PLAN COMMISSION

OFFICIAL NOTICE & AGENDA

REPORT TO PLANNING COMMISSION

SUBJECT: Preliminary Plat Review – Oriole Heights

OVERALL SITE PLAN
 NSG DEVELOPMENT, LLC.
 2800 MARTIN LANE
 WAUSAU, WISCONSIN 54401

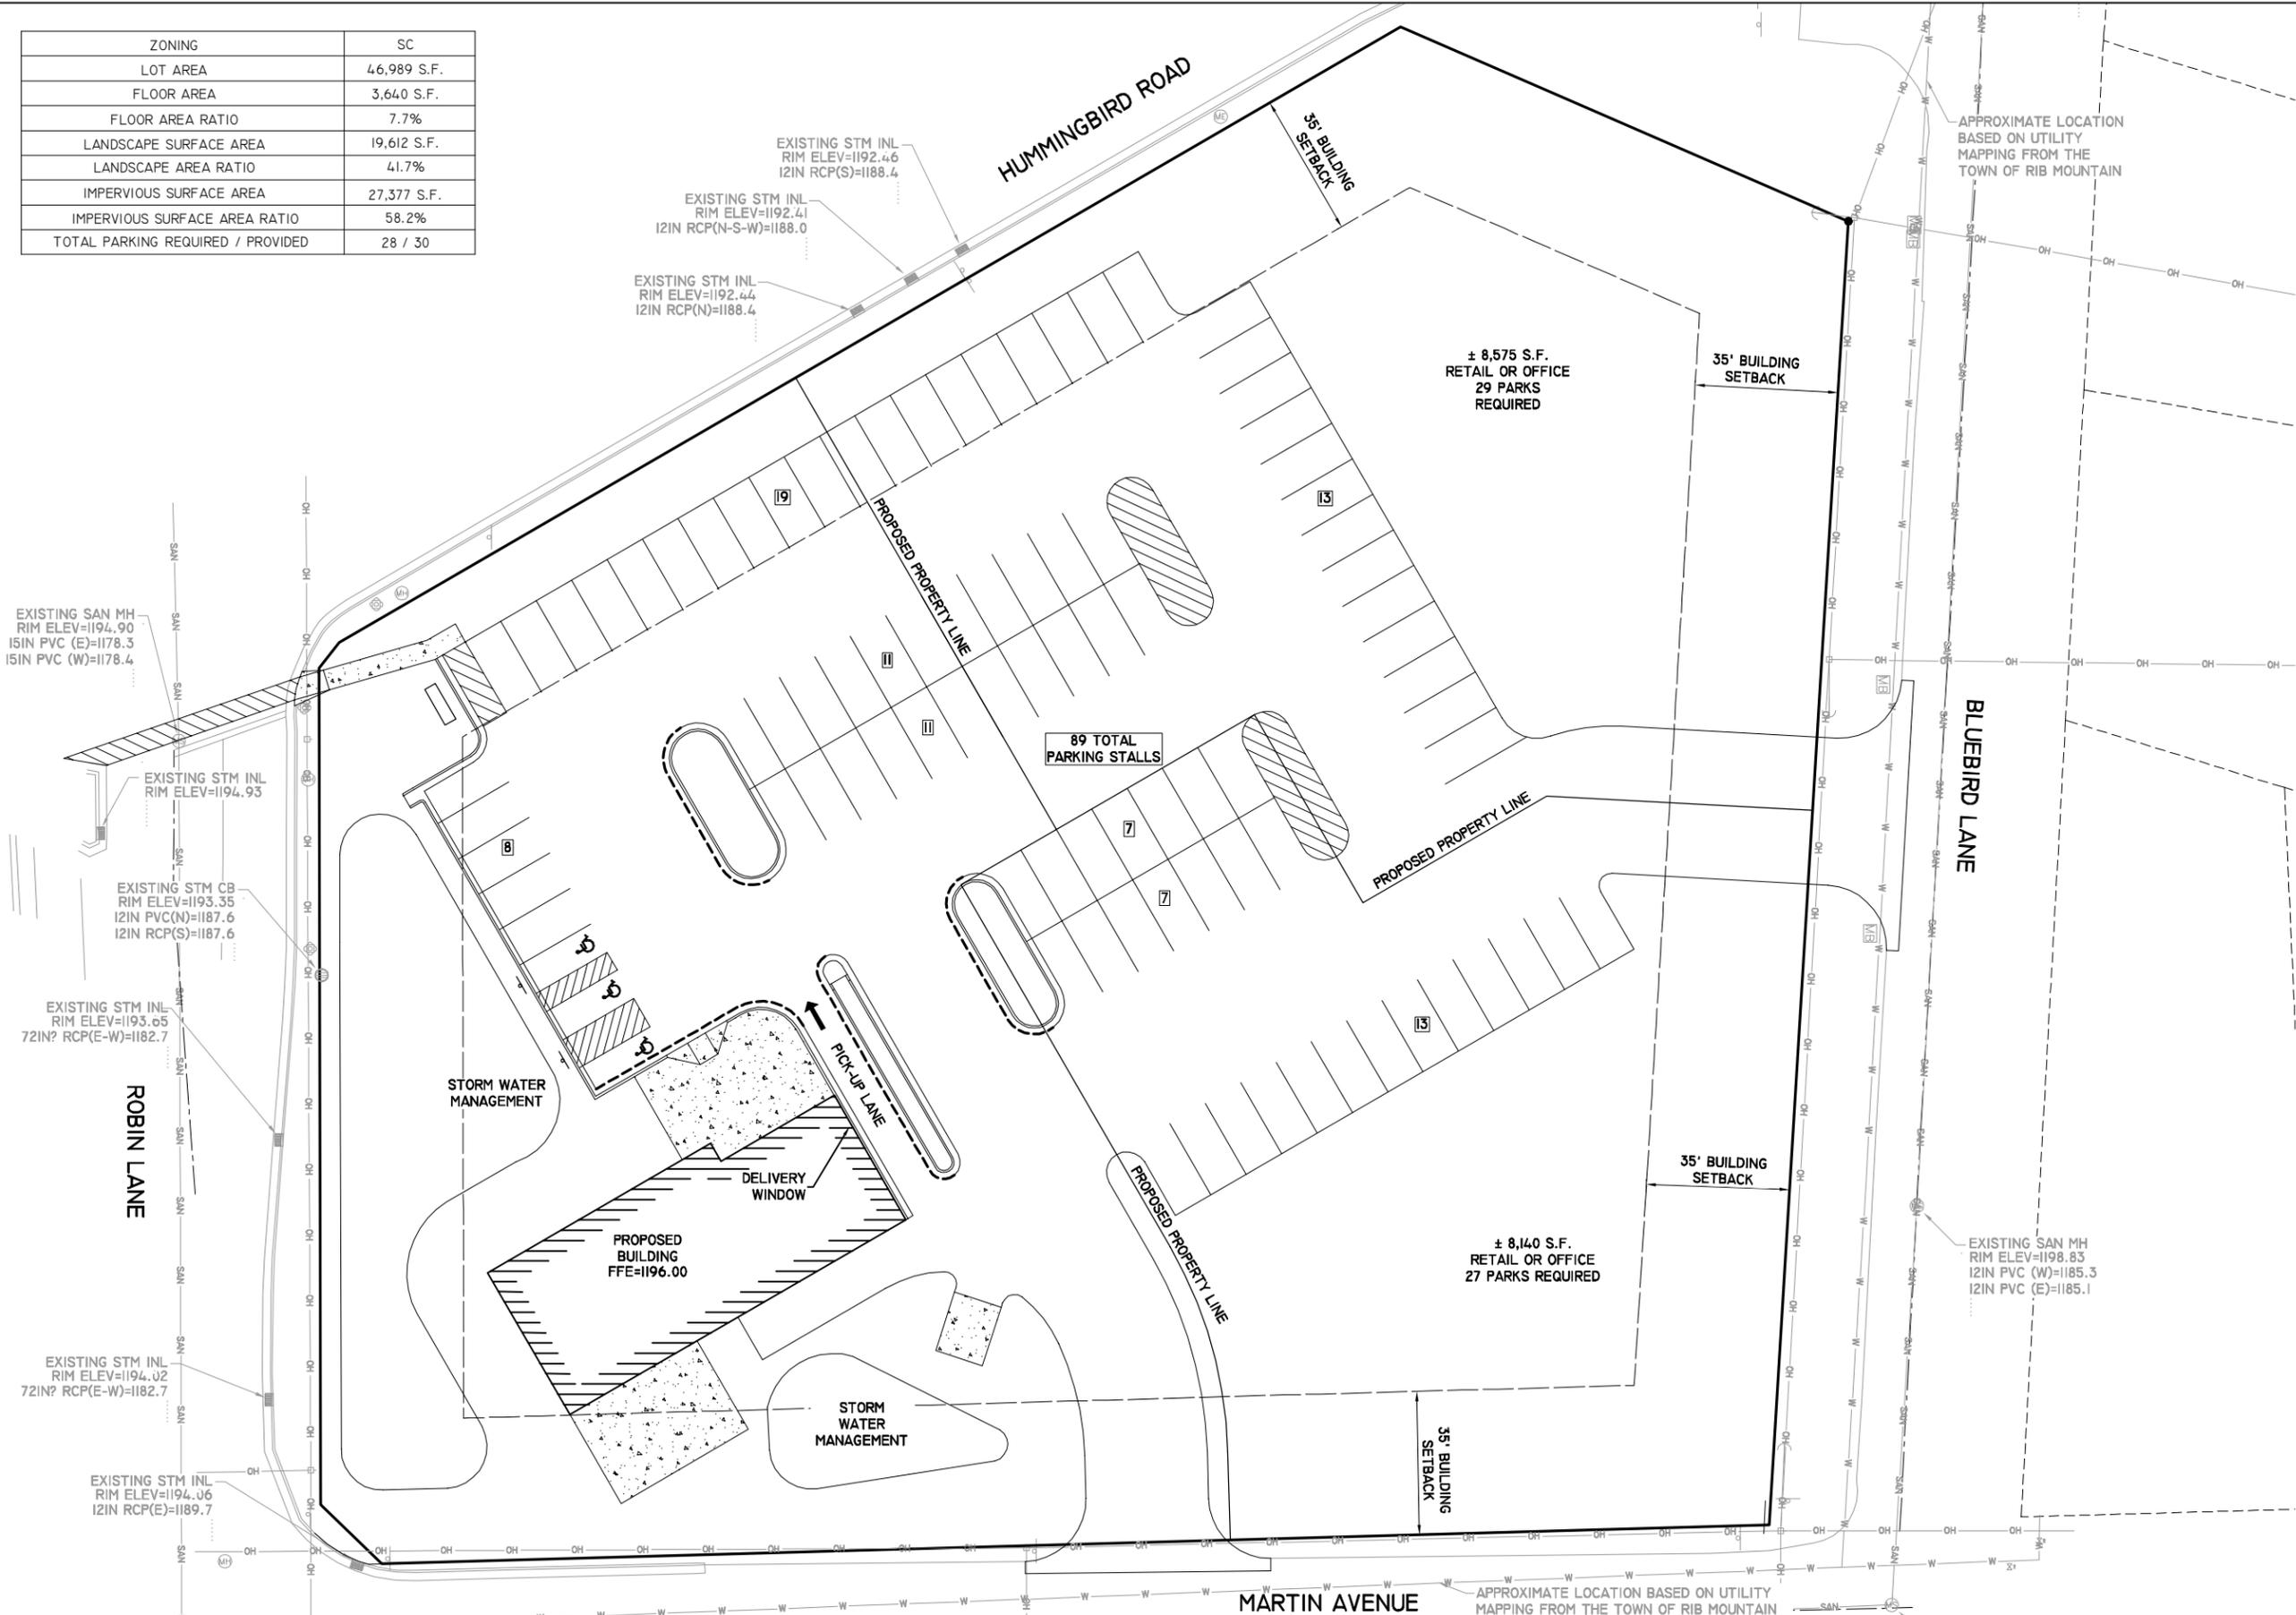
This requirement is met as landscape islands are separated by curb. Per the Town Landscaping standards, curb needs to be added to the perimeter of the parking lot.

- Setback identified for Hummingbird Road needs to be amended to code minimum of 45 feet, as the right-of-way for Hummingbird is greater than 100 feet in width.
- Approval should be conditioned upon applicant specifying pylon sign location. Per code, it must be set back a minimum of 10 feet from any property line.
- Approval should be conditioned upon receiving specifications for screening of the refuse/recycling containers. Plans identify location, but no architectural detail was provided.
- Approval should be conditioned on receiving photometric plan meeting the performance standards of the Zoning Ordinance.

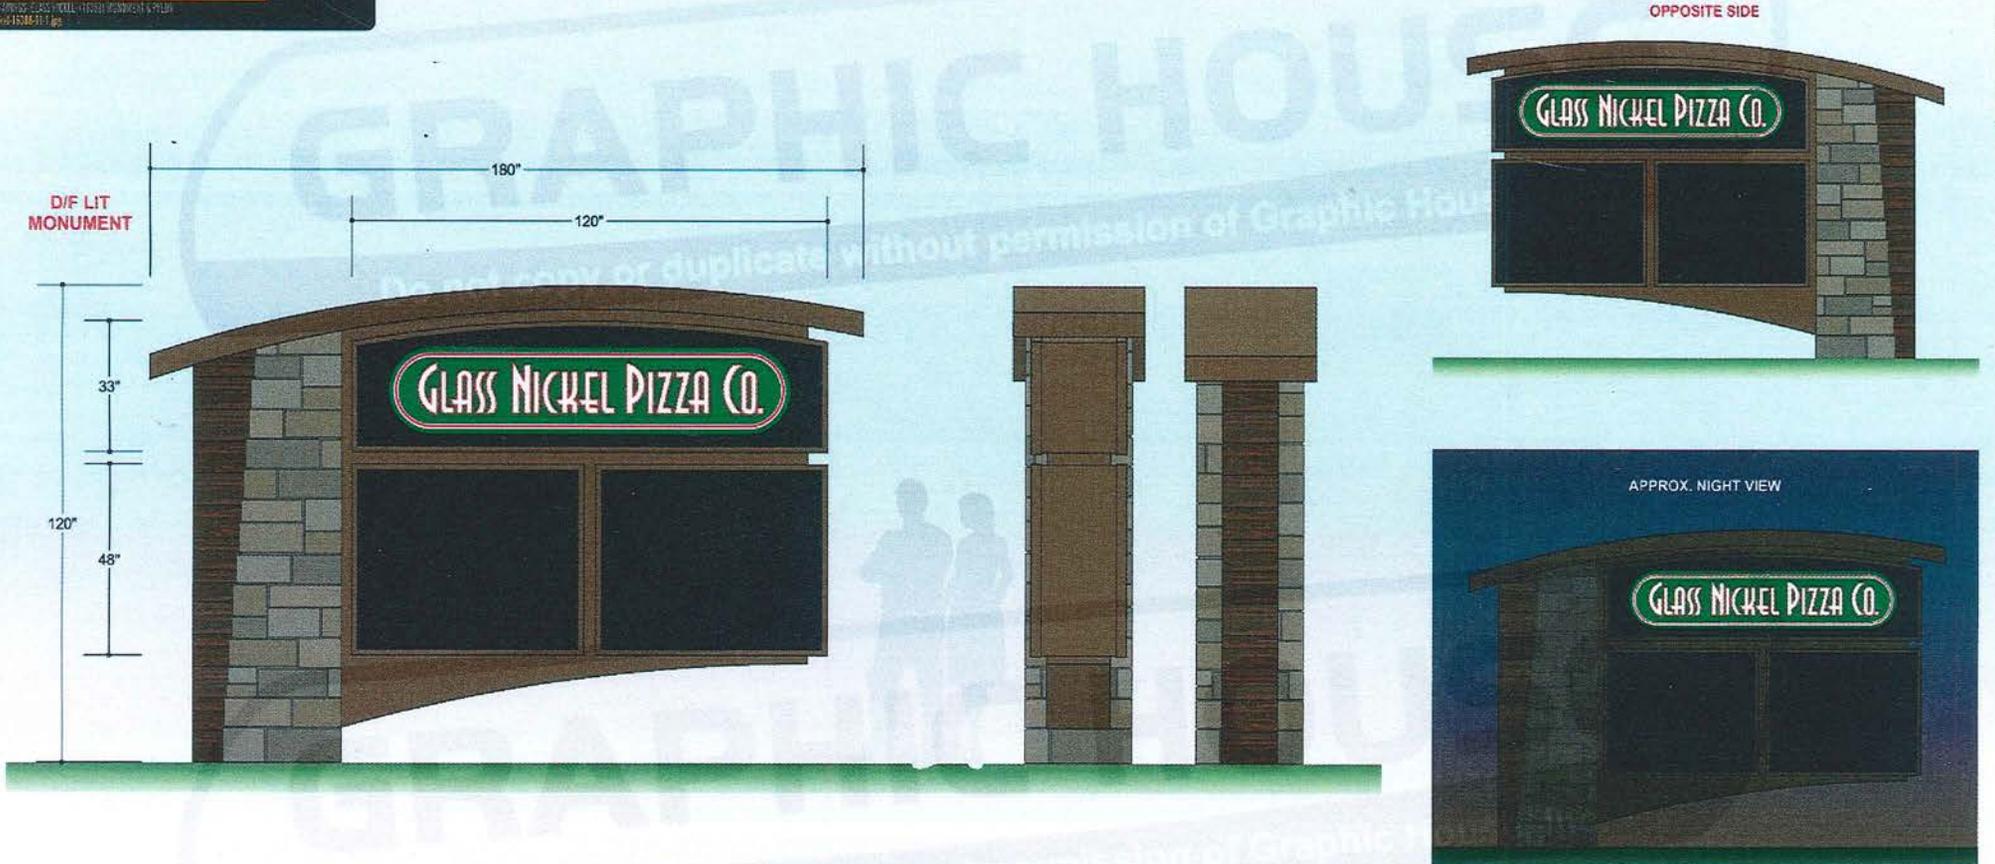
Considering the proposed sign configuration includes a monopole structure, it does not appear the sign would impede or obstruct vision within the standard vision triangles. However, this condition cannot be confirmed until submittal of final plans.
